**FPL REPLY TO:**  
**STEAM GENERATOR TUBE INSPECTION DISCUSSION POINTS**  
**PREPARED BY THE OFFICE OF NUCLEAR REACTOR REGULATION**  
**FLORIDA POWER AND LIGHT COMPANY**  
**SAINT LUCIE NUCLEAR PLANT UNIT 2**  
**DOCKET NO. 50-389**

The following discussion points have been prepared to facilitate the phone conference arranged with Florida Power & Light Company to discuss the results of the steam generator (SG) tube inspections to be conducted during the upcoming St. Lucie Nuclear Plant, Unit 2 refueling outage (SL2-16). This phone call is scheduled to occur toward the end of the planned SG tube inspection interval, but before the unit completes the inspections and repairs.

**Status of inspections as of 0800 on 5/5/06 for SL2-16.**

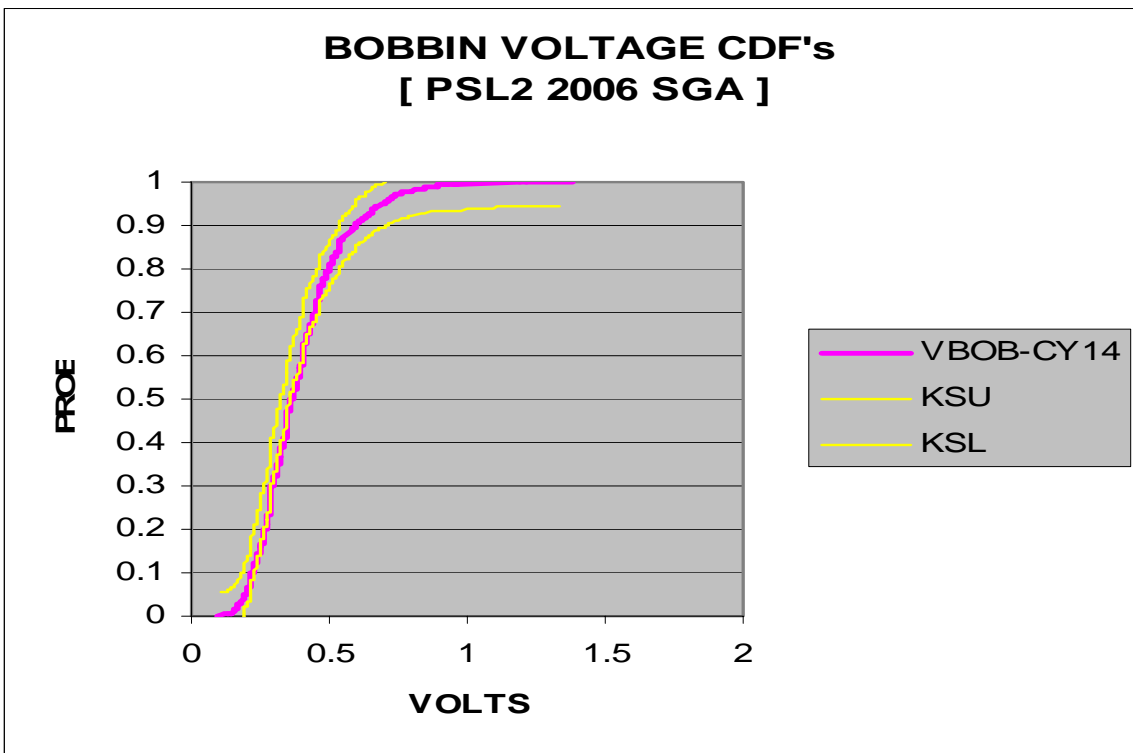
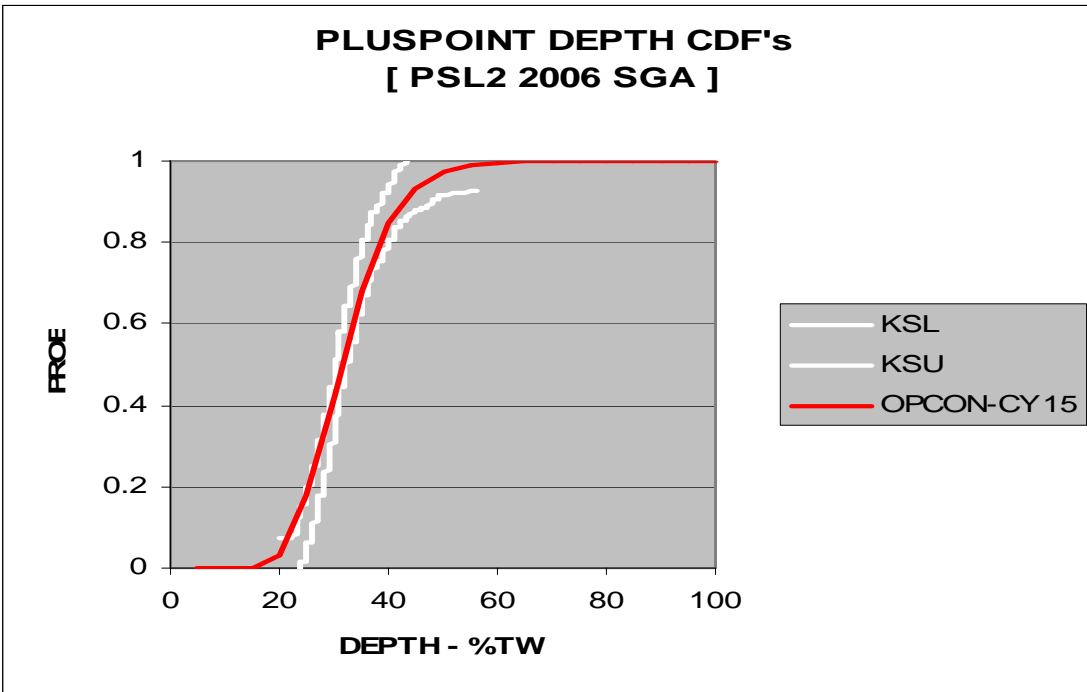
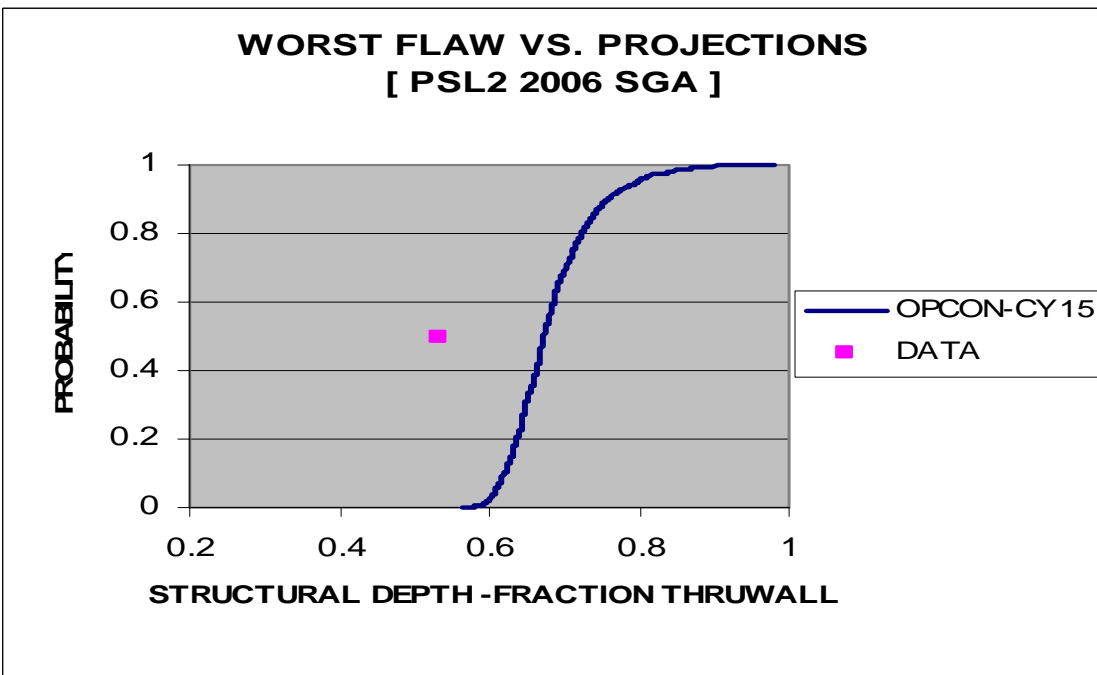
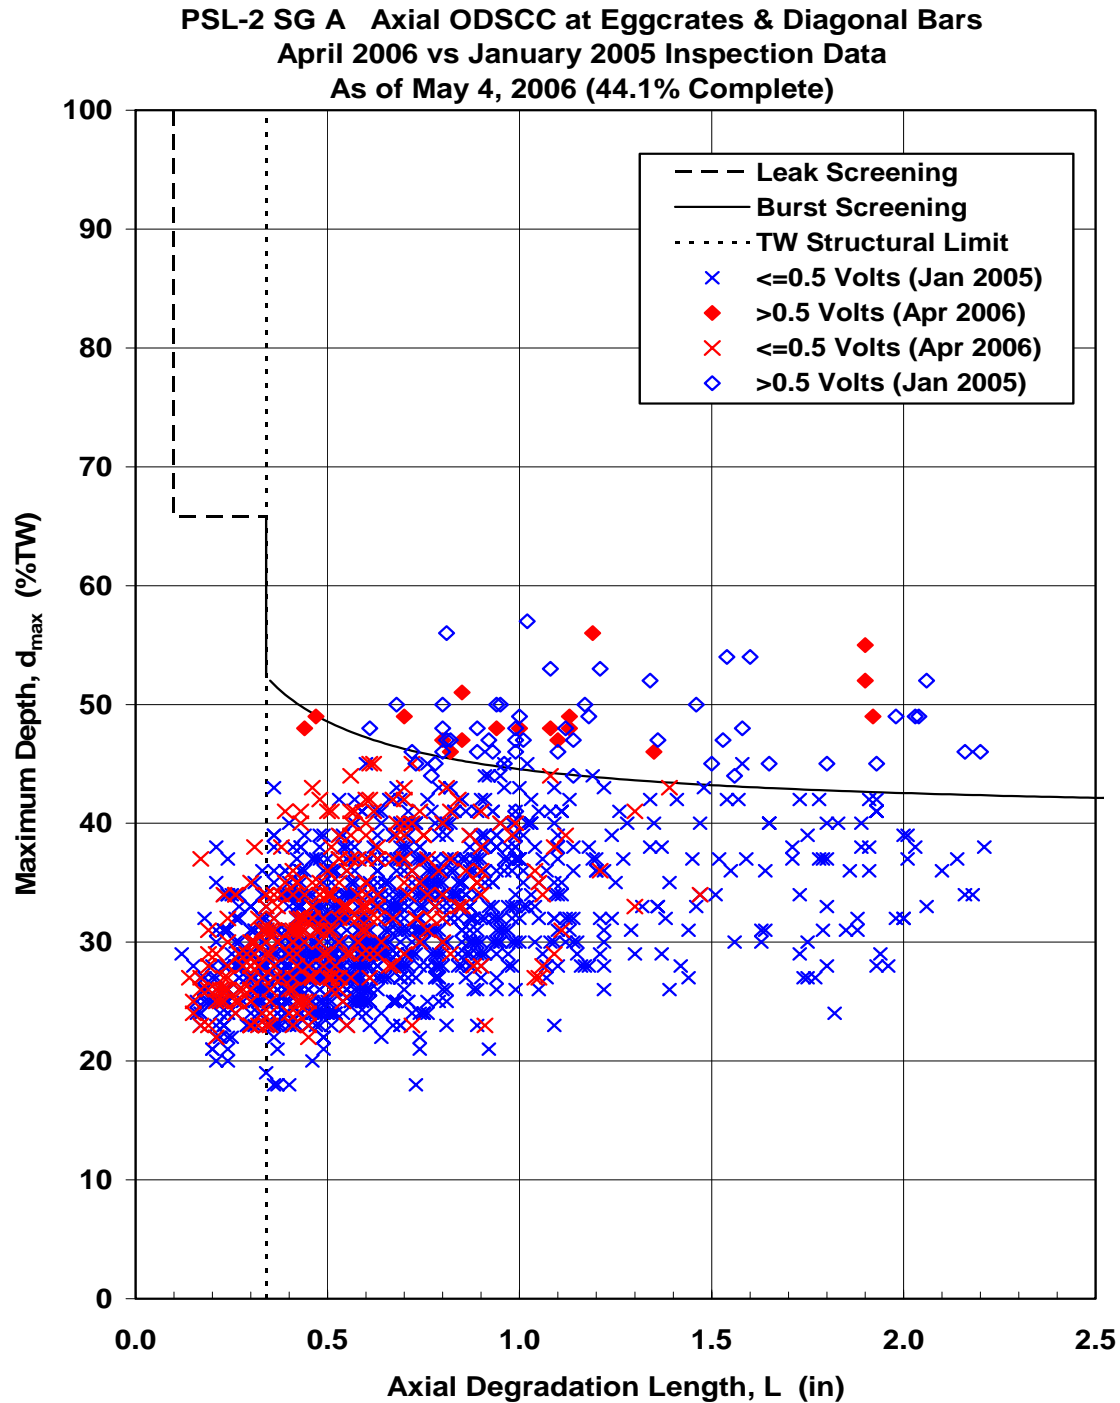
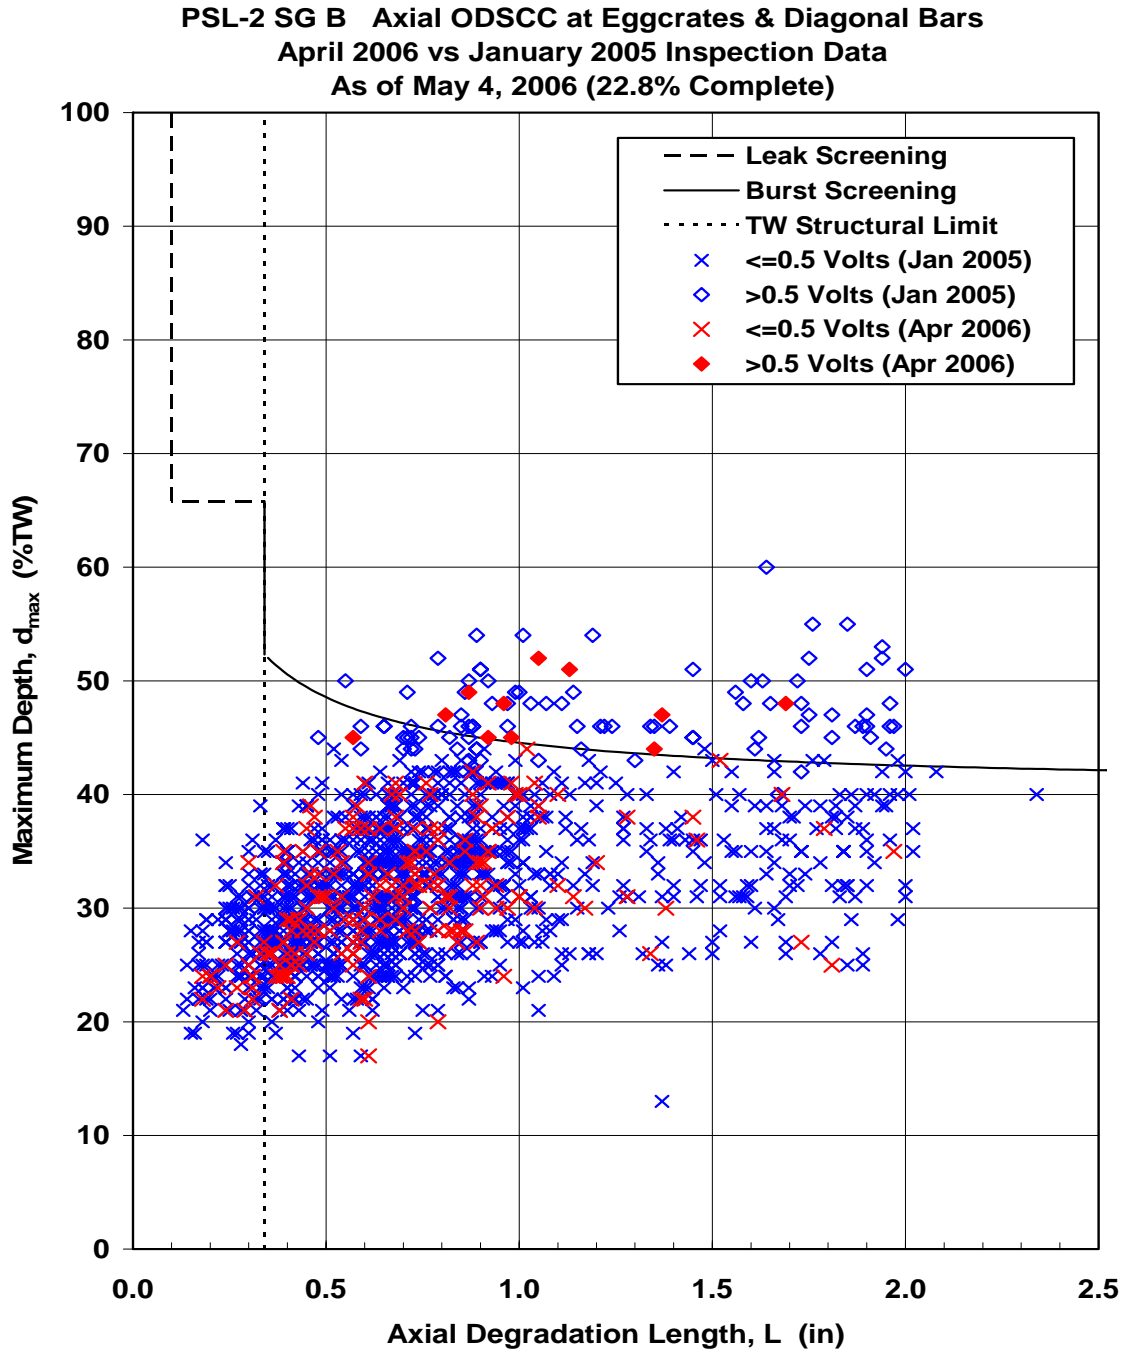
11. Discuss any unexpected or unusual results.

Reply – The only unexpected results is that the number of indications observed in the SGs is lower than expected. The voltage, depth and length distributions are consistent with observations from prior inspections and within expectations (Refer to Figures 1-5).
